**PLANNING APPROVAL,
PLANNED UNIT DEVELOPMENT &
SUBDIVISION STAFF REPORT****Date: July 22, 2010**

<u>NAME</u>	Saint Ignatius Parish Subdivision, Resubdivision of
<u>SUBDIVISION NAME</u>	Saint Ignatius Parish Subdivision, Resubdivision of
<u>LOCATION</u>	3650 Springhill Avenue (Northwest corner of Springhill Avenue and Tuthill Lane)
<u>CITY COUNCIL DISTRICT</u>	District 7
<u>PRESENT ZONING</u>	R-1, Single-Family Residence District
<u>AREA OF PROPERTY</u>	1 lot / 13.3 acres \pm
<u>CONTEMPLATED USE</u>	Planning Approval of the Master Plan for an existing Church and School in an R-1, Single-Family Residential District, for expansion of the site, Planned Unit Development approval to allow multiple buildings on a single building site, and Subdivision approval to create one legal lot.
<u>TIME SCHEDULE FOR DEVELOPMENT</u>	Immediate
<u>ENGINEERING COMMENTS</u>	Before Plat will be approved for signature, Engineering Department will require certification from the engineer that there is an adequate and functioning detention system(s) for any impervious area added to the site since 1984. Must comply with all storm water and flood control ordinances. Any increase in impervious area in excess of

SITE PLAN

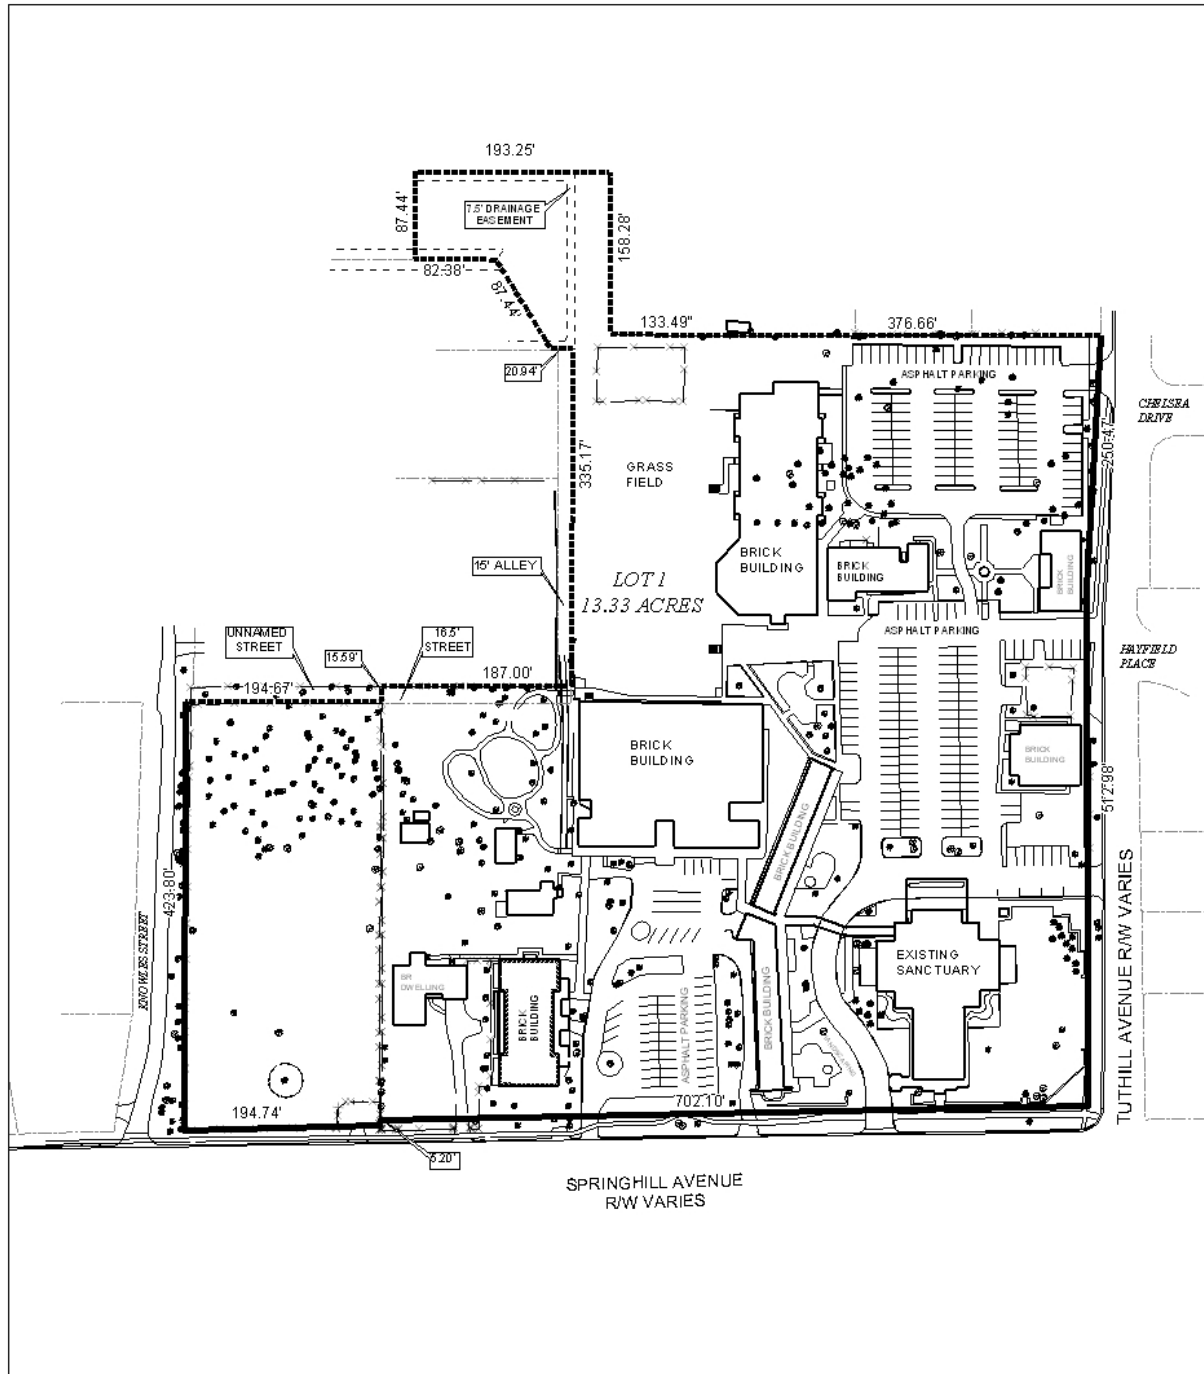
The overall site has three curb-cuts onto Tuthill Lane, five curb-cuts onto Spring Hill Avenue, and no curb-cuts onto Knowles Street. The site should be limited to its existing curb-cuts, and any changes to existing curb-cuts must be approved by the Planning Section of Urban Development and Traffic Engineering, and comply with AASHTO standards. Access to the abutting unnamed street/alley should be denied, as should access to Knowles Street.

It should be pointed out that the property being brought into the main site has an existing wooden privacy fence. It appears that a portion of the fence is within the right-of-way for Spring Hill Avenue, and this will be exacerbated by the required dedication. Any new application to the Planning Commission for new development of the overall site should include plans to relocate the fence to meet all required setbacks.

The 25-foot minimum building setback line is not depicted on the plat or site plans. The plat and site plans should be revised to depict the 25-foot minimum building setback line from all public rights-of-way, and should reflect any required dedication.

The proposed use of the expanded area is greenspace. This implies that there is no active or dedicated use of the site other than perhaps casual use: the greenspace area cannot be used for parking or for play areas. If the intent of the application is in fact to utilize the greenspace for active recreational uses associated with the school, the application should be heldover so that the site plan can be revised to show required buffering, proposed site improvements, etc.

- 1) Revision of the plat and site plan to reflect dedication of right-of-way along Spring Hill Avenue (50-feet from centerline) and Knowles Street (25-feet from centerline), including a corner radius for that portion of the site not previously subdivided;

- 2) Revision of the plat and site plan to depict and label the 25-foot minimum building setback from all public rights-of-way;
- 3) Revision of the site plan to include a note stating that the greenspace will not be utilized for active school, playground or church related uses;

- 4) Placement of a note on the plat and site plan stating that the site is limited to the three existing curb-cuts onto Tuthill Lane, the five existing curb-cuts onto Spring Hill Avenue, denied access to Knowles Lane and the unnamed street/alleys abutting the site, with any changes to the existing curb-cuts to be approved by the Planning Section of Urban Development and Traffic Engineering, and to comply with AASHTO standards;

- 7) Placement of a note on the plat and site plan stating that the existing wooden privacy fence located within the right-of-way for Spring Hill Avenue and Knowles Lane will be relocated to meet all required setbacks on any future plan submitted to the Planning Commission for review;
- 8) Placement of a note on the plat and site plan stating that approval of all applicable Federal, state and local agencies is required for endangered, threatened or otherwise protected species, prior to the issuance of any permits or land disturbance activities;
- 9) Submission of a revised Planning Approval site plan to the Planning Section of Urban Development prior to signing the final plat; and
- 10) Full compliance with all other municipal codes and ordinances.
